Rep No.B21058

Notification regarding Change in the Power Adapter for the OCR Checker of DH Series Low-Voltage Air Circuit Breakers

Attachment
Change in Power Adapter

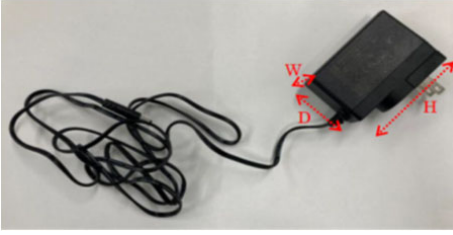
Before change	After change
External photo		
Dimensions (mm)	W33 x H45.5 x D23.5	W30.3 x H76.0 x D48.2
Mass (g)	70	130
Cord length (m)	1.8	1.8
Safety standard certification	CE,PSE	CE,PSE,UKCA
